Attachment B- Staff Report

City of Phoenix PLANNING & DEVELOPMENT DEPARTMENT

Staff Report Z-SP-3-18-7 September 7, 2018

Request From: [C-2 BAOD](#) (10.27 acres)
Request To: [C-2 SP BAOD](#) (10.27 acres)
Proposed Use Special permit to allow self-service storage, household moving center (truck rental), and all underlying C-2 uses

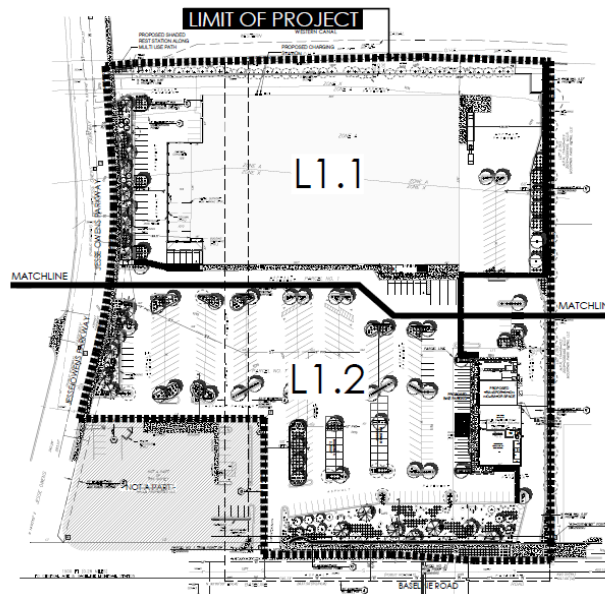
The conceptual site plan also depicts two new buildings near the southern portion of the site. These buildings consist of 2,150 square feet and 2,400 square feet respectively, and contain self-service storage units. These structures are depicted perpendicular to Baseline Road and are not screened by perimeter walls, landscaping, or access gates.

Staff does not recommend general conformance to the Overall Site Plan (see attached) submitted with the request. The subject site was permitted and developed prior to the adoption of the Baseline Area Overlay District and there are numerous features depicted on the site plan, reflecting the existing development, which would not comply with the current requirements of the requested C-2 SP BAOD zoning designation. These features include, but are not limited to the following:

- The site plan does not include shaded and raised walkways within the parking lot, which is a required design guideline of the BAOD (651.E.2.a).
- The site plan does not propose overhangs a minimum of 10 feet in width along all pedestrian walkways adjacent to buildings, which is a required design guideline of the BAOD (651.E.2.c).

Site improvements and/or redevelopment of the site will require the developer to bring the site into compliance with requirements of the Baseline Area Overlay District. However, these requirements may vary depending on the city's proportionality policies. The policy establishes guidelines for incremental

improvements of existing commercial developments. Therefore, staff stipulations individually address particular areas of concern including BAOD requirements regarding the Baseline Road landscape setback, pedestrian walkways, parking lot landscaping, and landscaping in the project's main entry. See Background Item Nos. 8-12 for detailed discussion regarding these stipulations.

Conceptual Elevations
 Source: Amerco Real Estate Company

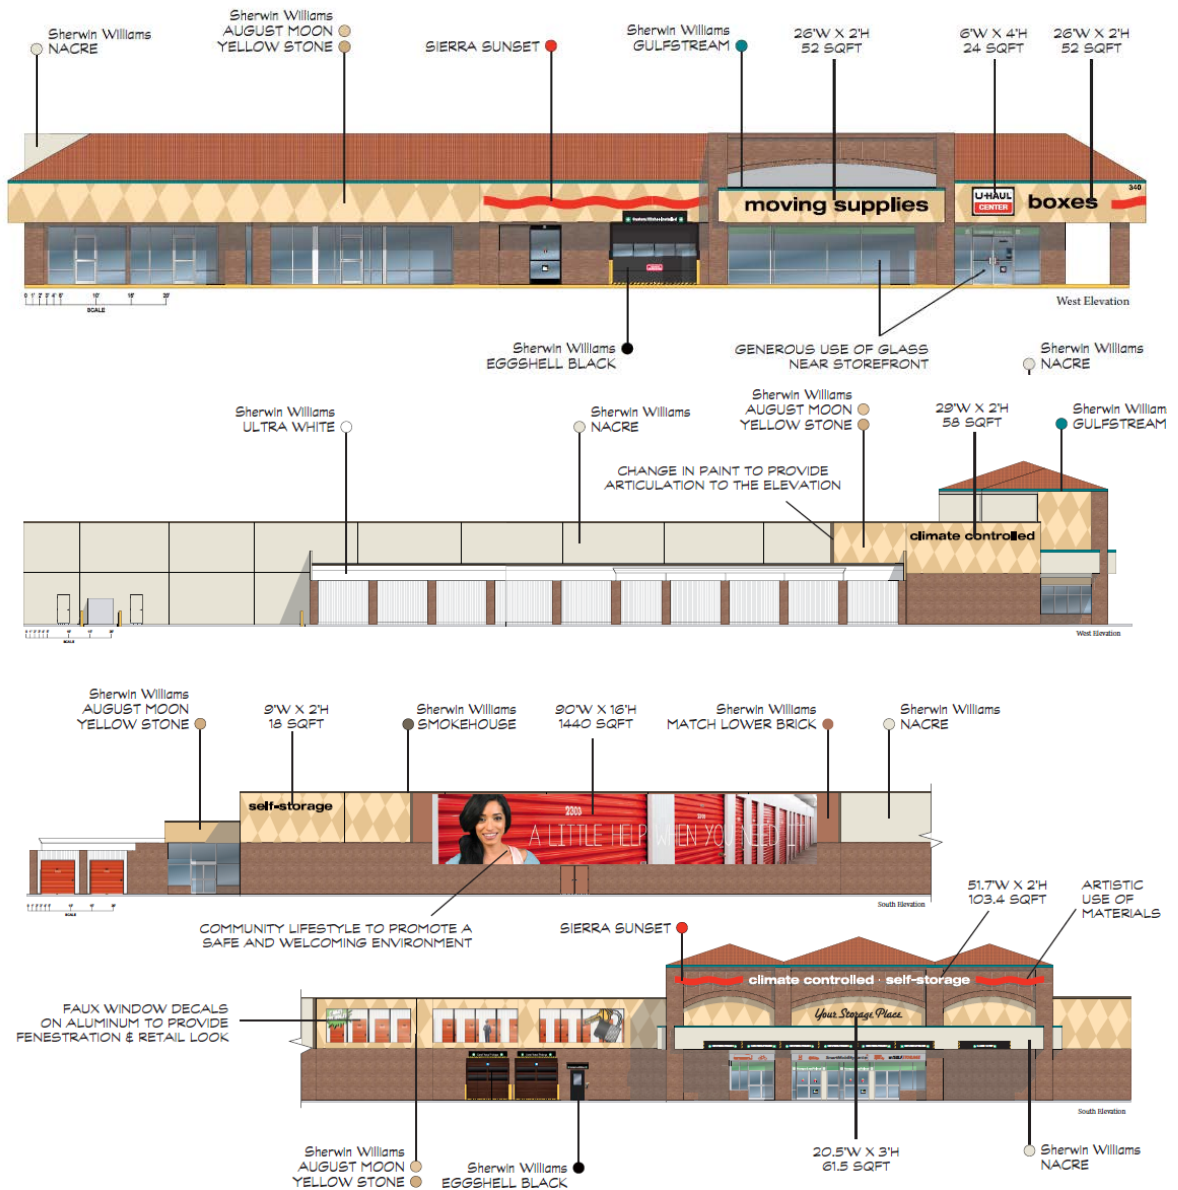
The applicant is proposing to redesign the exterior facades of existing buildings to include multiple paint colors, graphic signs, and architectural accent features.

Staff does not recommend general conformance to the proposed elevations as they do not exceed the Guidelines for Design Review as outlined in Section 507. Tab A of the Zoning Ordinance.

Staff does recommend a requirement that all building elevations, including those facing or visible from the Western Canal, shall contain multiple exterior accent materials, architectural embellishments, and/or detailing such as green screens, textural changes, pilasters, offsets, recesses, variation in window size and location, and/or other overhang canopies. Providing these additional architectural elements will create visual interest for the site and help to mitigate the impacts of the building massing, particularly along the Western Canal. This is addressed in Stipulation No. 4.

*Preliminary Landscape Plan
(Detail: Northeast corner of site)
Source: Amerco Real Estate Company*

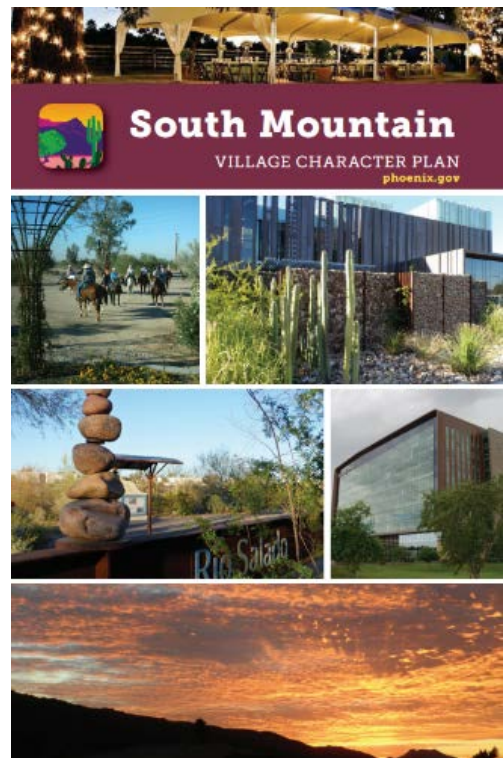
Stipulation No. 10 furthers the goal of this BAOD design guideline by requiring a pedestrian walkway which provides connectivity between Baseline Road and the Western Canal, as depicted on the Preliminary Landscape Plan date stamped August 1, 2018. This stipulation is intended to provide a connection between the walkways required by the BAOD within the parking lot and the north and south perimeter of the site to promote increased access to the amenities along the Western Canal and the multi-use trail along Baseline Road.

10. The developer shall provide a pedestrian walkway constructed of porous, interlocking, or open-grid pavers or another alternative surface material, which provides connectivity between Baseline Road and the Western Canal, as depicted on the Preliminary Landscape Plan date stamped August 1, 2018 and as approved by the Planning and Development Department.

CONCEPTUAL
 AMENITIES PLAN
 08/01/2018

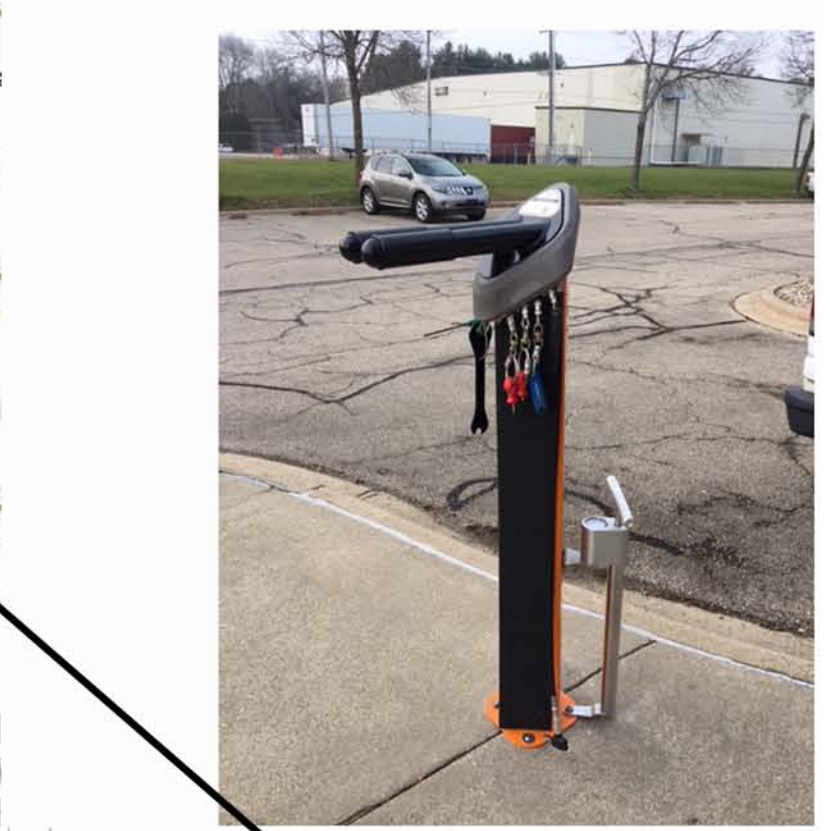
Staff also recommends a shaded seating area with benches and/or ramadas, bicycle parking, and a bicycle repair station to serve a diverse array of canal users.

All amenities are to be located along the northern property line, adjacent to the canal. Further, the enhanced open space containing these amenities shall consist of a minimum 3,000 square feet. Amenities shall be accessible from both the Western Canal and from Baseline Road. Connectivity to the amenities from Baseline Road will be provided via a pedestrian walkway that traverses the site. This is addressed in Stipulation No. 10. See Background Item No. 10 for a detailed discussion of the walkway.

- d. Bicycle repair station as depicted on the Conceptual Amenities Plan date stamped August 1, 2018 and/or as approved by the Planning and Development Department.
